NOTICE OF DECISION

DECISION OF THE HEARINGS OFFICER

NONCONFORMING USE / SITE PLAN REVIEW / ADJUSTMENT CASE NO.: NC-SPR-ADJ19-01

STOCKWELL RENTALS NEW CONSTRUCTION

SHEET TITLE
SITE PLAN

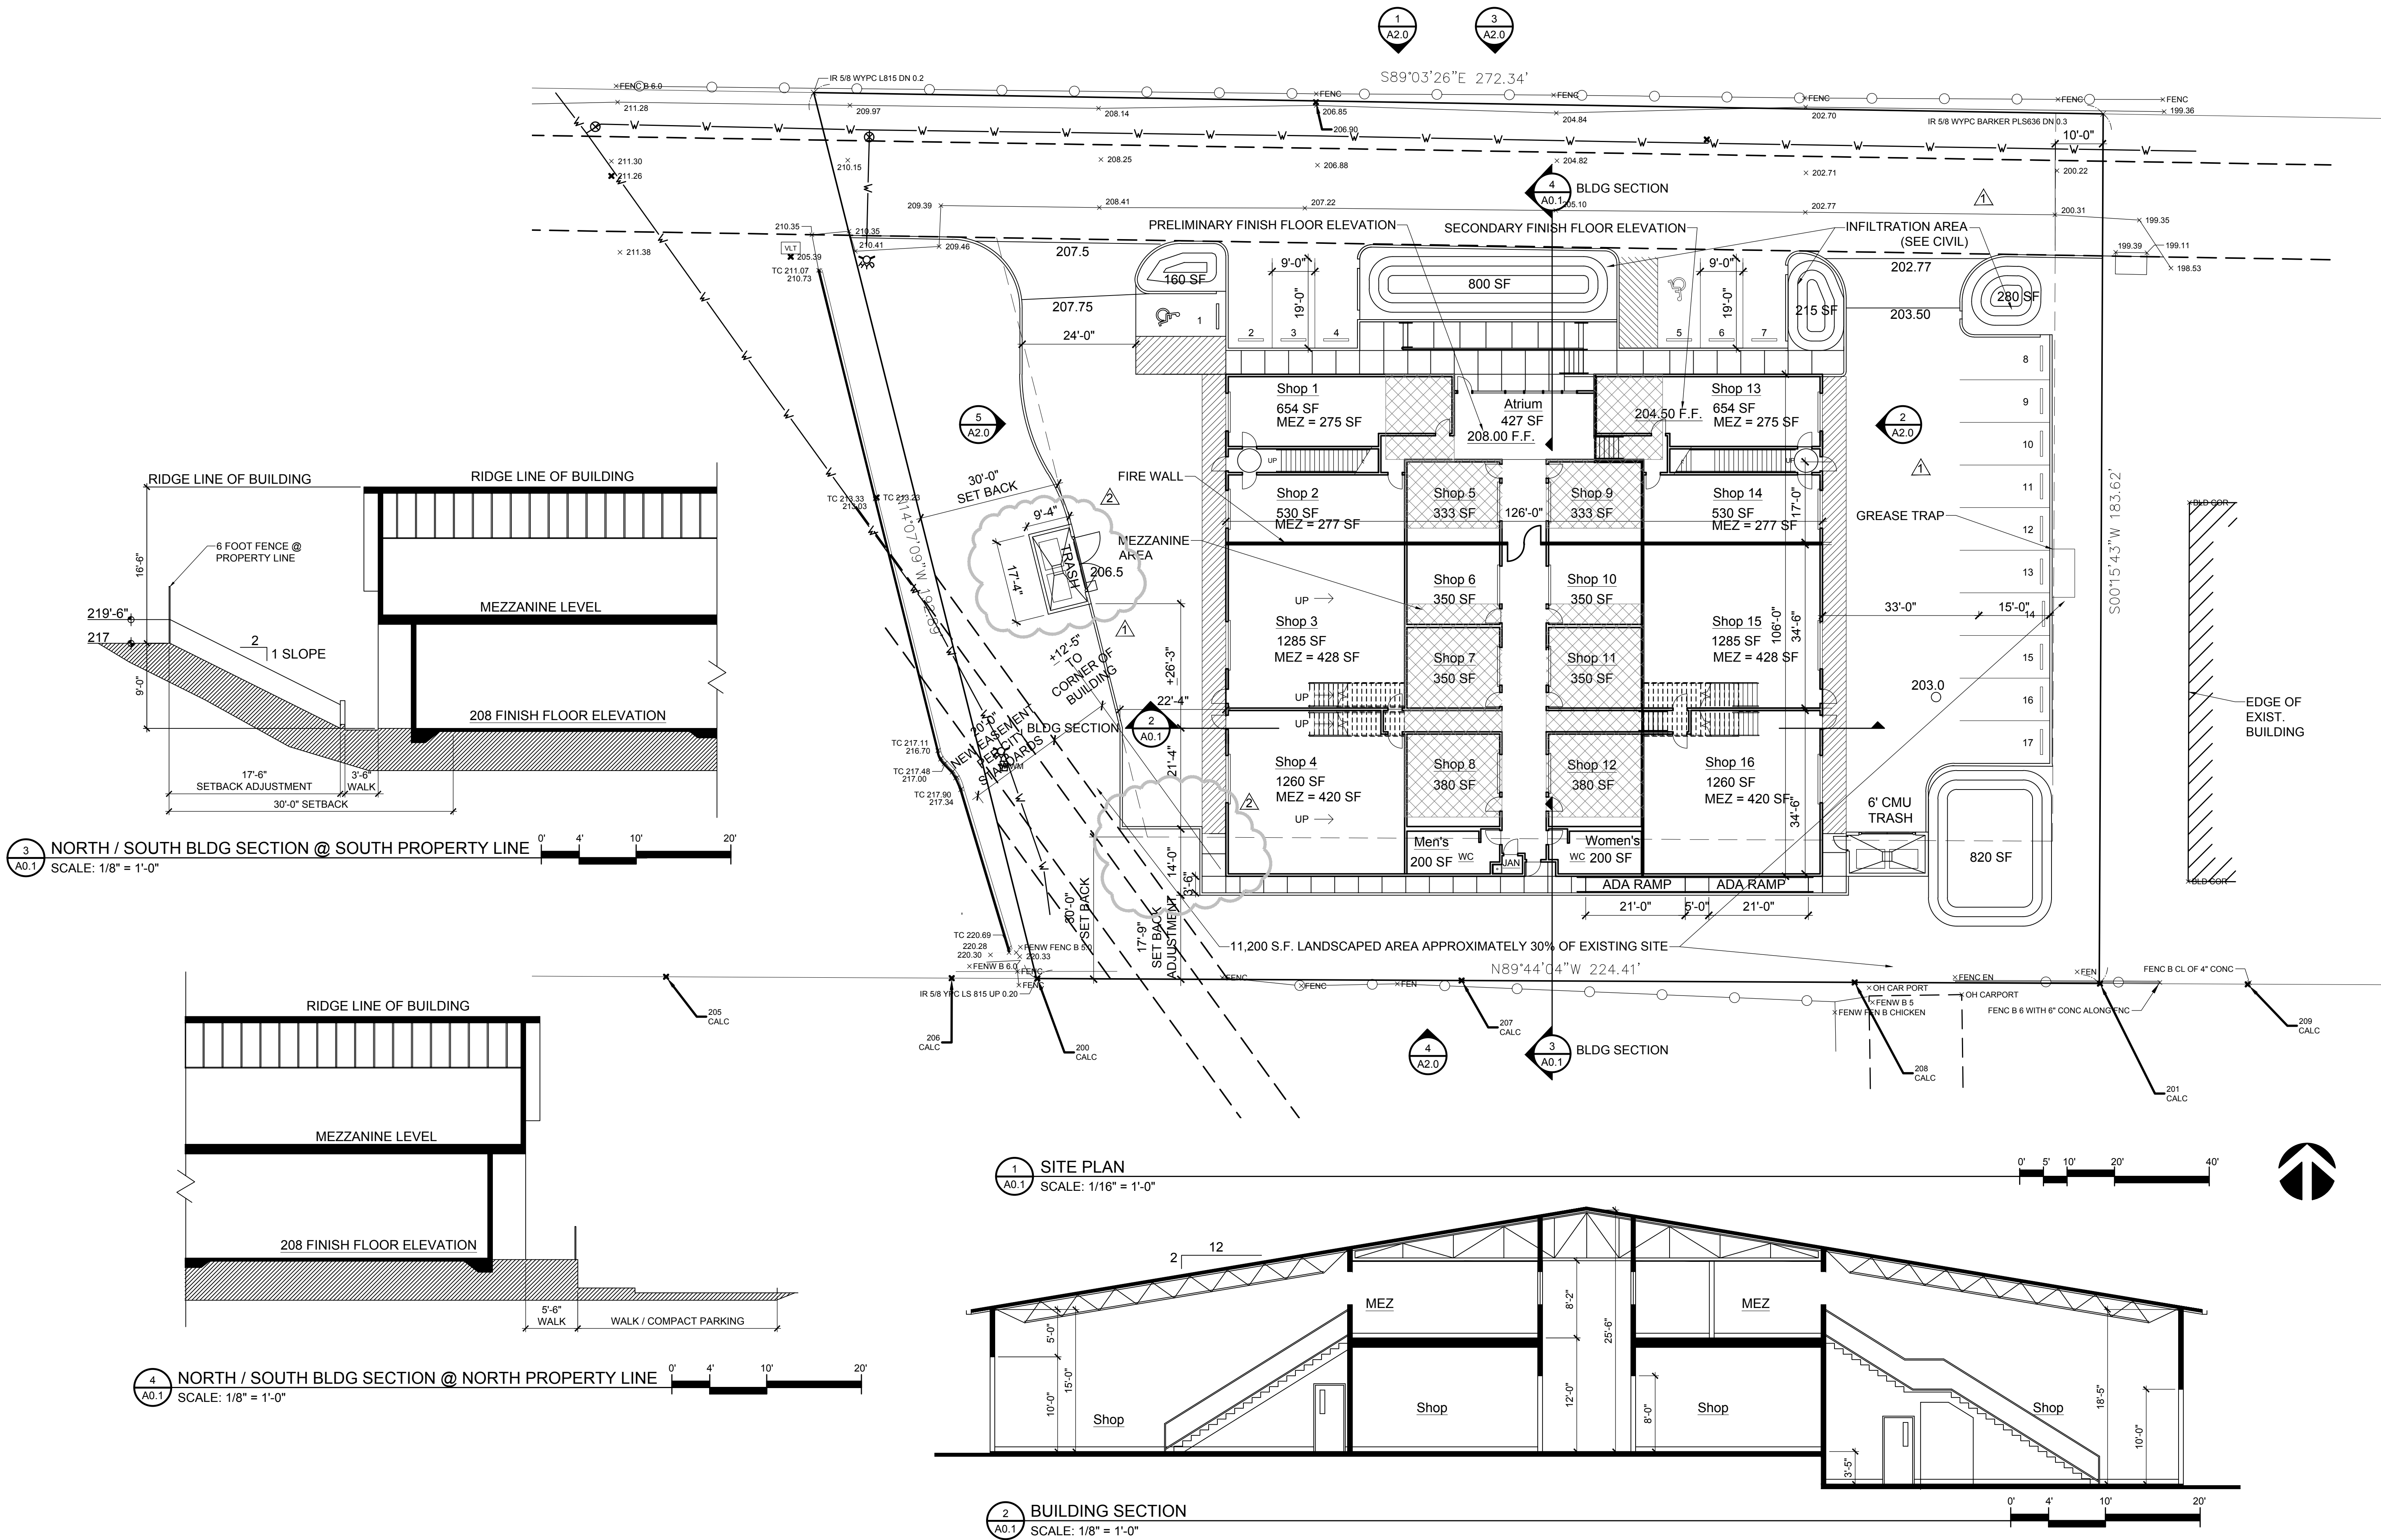
The Hearings Officer notes that the applicant provided a site plan indicating approximately 11,200 square feet, or 30 percent of the development site will be landscaped. The Hearings Officer finds the proposed development exceeds the minimum 15 percent landscape standard for the development site within the IP zone.

The Hearings Officer notes that the proposed site plan does not indicate details of the solid waste receptacle area. Therefore, the following condition is imposed:

The Hearings Officer notes that the proposed building is approximately 20,000 square feet in size. According to the applicant, the commercial kitchen space will be leasable to different organizations to prepare foods. Because of this, using an employee count to determine parking is not appropriate. General manufacturing uses require 1 off-street parking space per 5,000 square feet of floor area. The proposed building requires a minimum of 4 off-street parking spaces ($20,000 / 5,000 = 4$). In accordance with the site plan provided, none of the parking spaces are planned to be compact spaces. For parking areas with 20 off-street parking spaces or less, the maximum allowed parking is 2.5 times the number of spaces required for the proposed use. In this case, the maximum allowed parking is 10 spaces, however, the applicant's site plan proposed 17 off-street parking spaces, which exceeds the maximum allowed, pursuant to SRC Chapter 806, Table 806-2. Because the proposal does not meet this requirement, the following condition shall be imposed:

The Hearings Officer notes that the proposed site plan shows the parking area will be approximately 12,707 square feet in size. The minimum interior landscape required is 635 square feet ($12,707 * 0.05 = 635.35$). The applicant's site plan shows approximately 2,275 square feet of interior landscaping which exceeds the minimum required.

The Hearings Officer notes that the proposed buildings are approximately 20,000 square feet in size, which requires a minimum of 4 bicycle parking spaces. Neither the applicant's written statement nor the proposed site plan depicts the location of the four required bicycle parking spaces for the proposed use.

Condition 3: At the time of building permit application, the applicant shall provide evidence that the proposed solid waste service area will comply with the standards of SRC 800.055.

Condition 4: At the time of building permit application, the applicant shall provide a revised site plan depicting no more than the maximum off-street parking allowance of 10 spaces -OR- prior to building permit application, the applicant shall apply for and obtain approval for a Class 2 Adjustment to the maximum allowed parking.

Condition 5: At the time of building permit application, the applicant shall provide a revised site plan providing 4 bicycle parking spaces which meet the development standards of SRC Chapter 806.060.

SHEET TITLE
ELEVATIONS

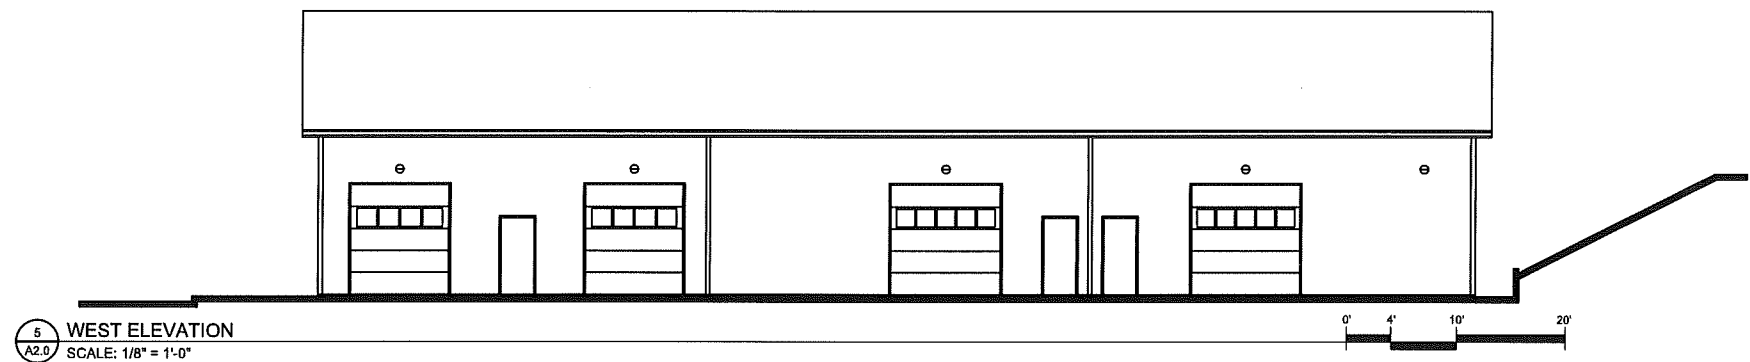
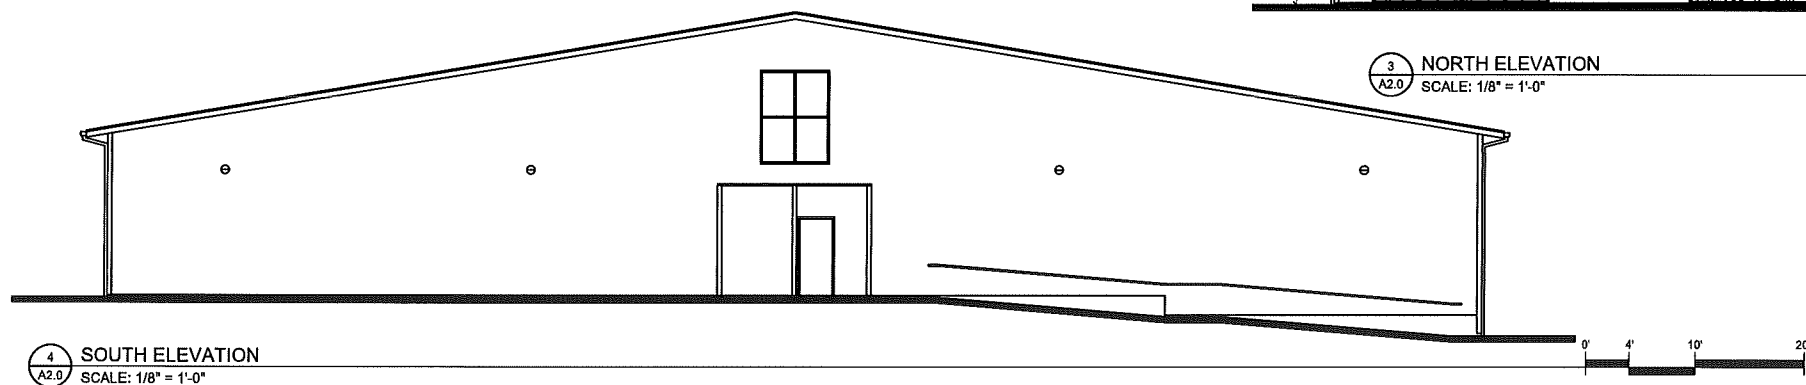
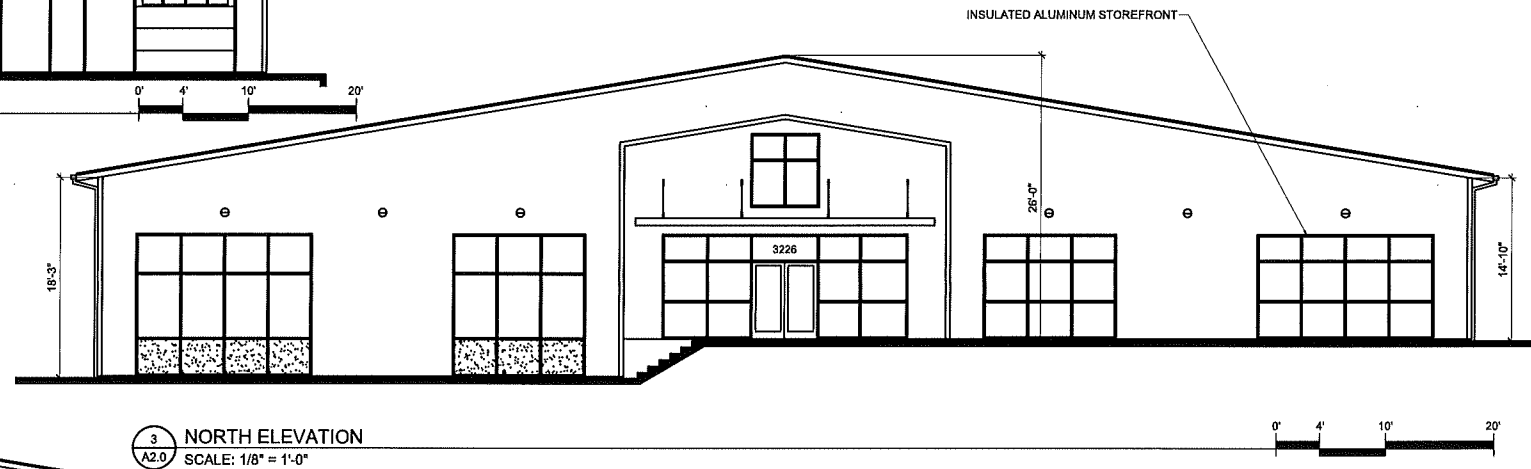
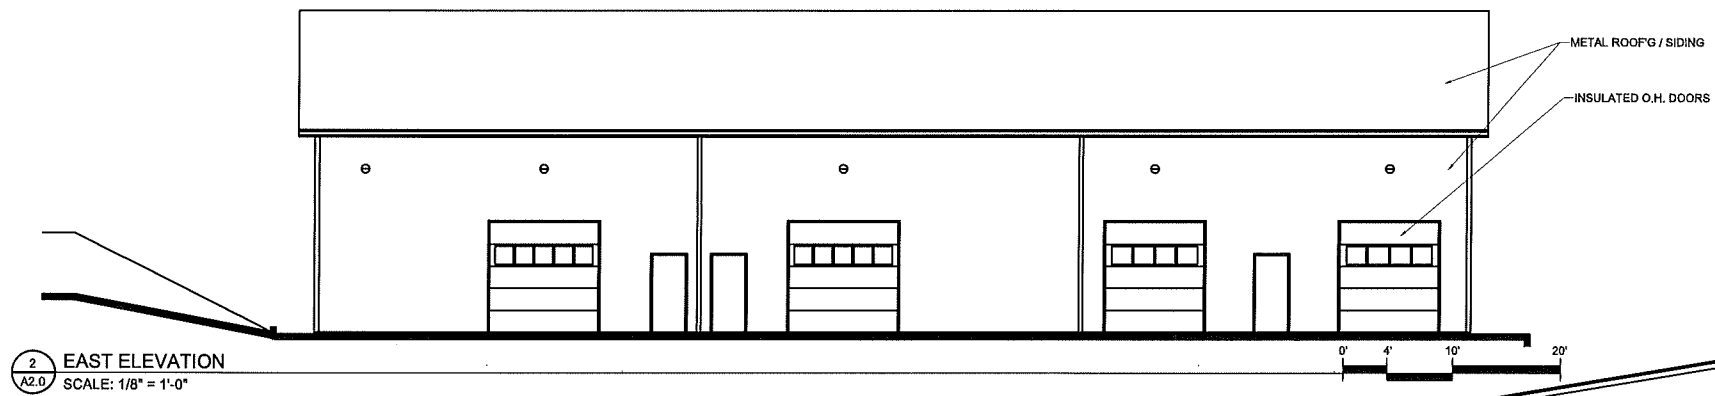
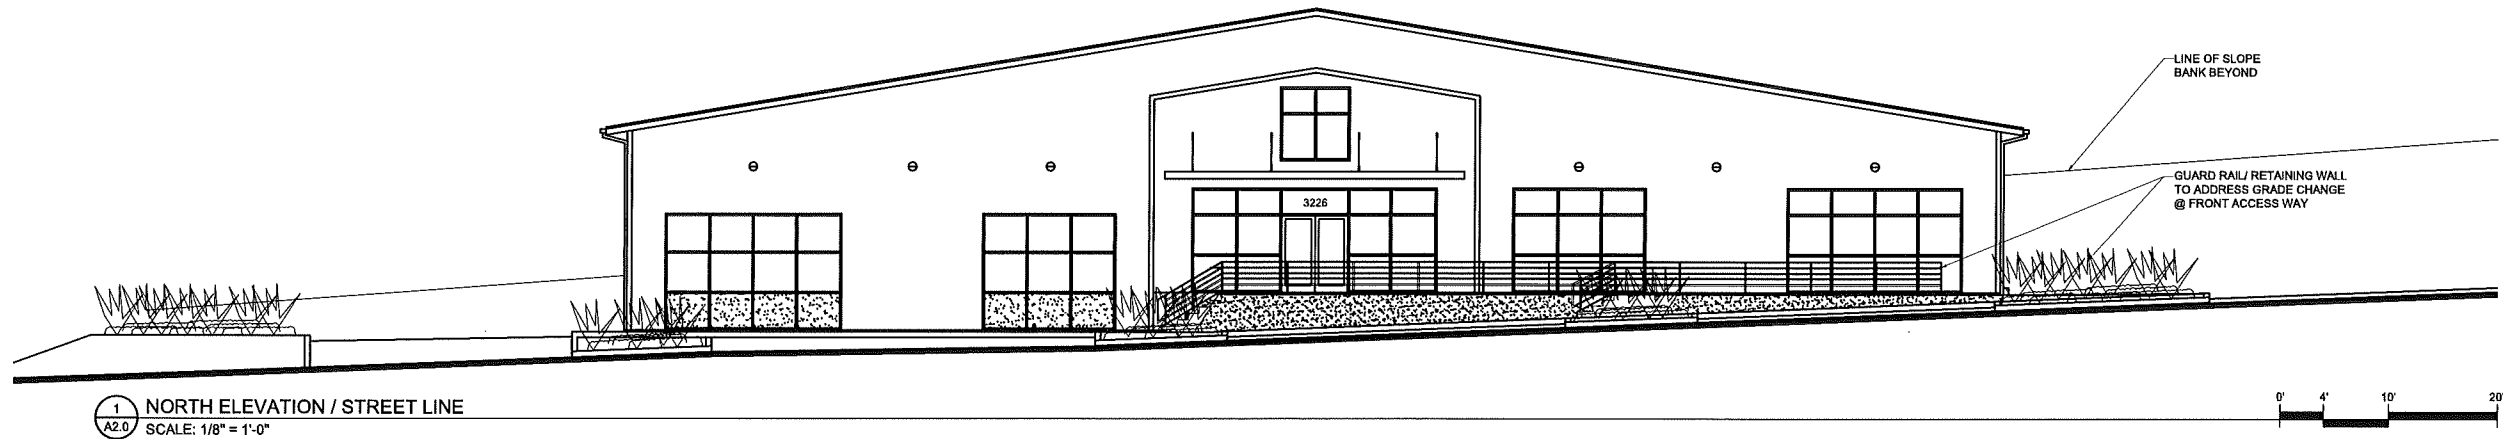
The Hearings Officer notes that the applicant has indicated on the building elevation plan that the building will be less than 45-feet in height. The building height will be verified to be less than 45 feet at the time of building permit review.
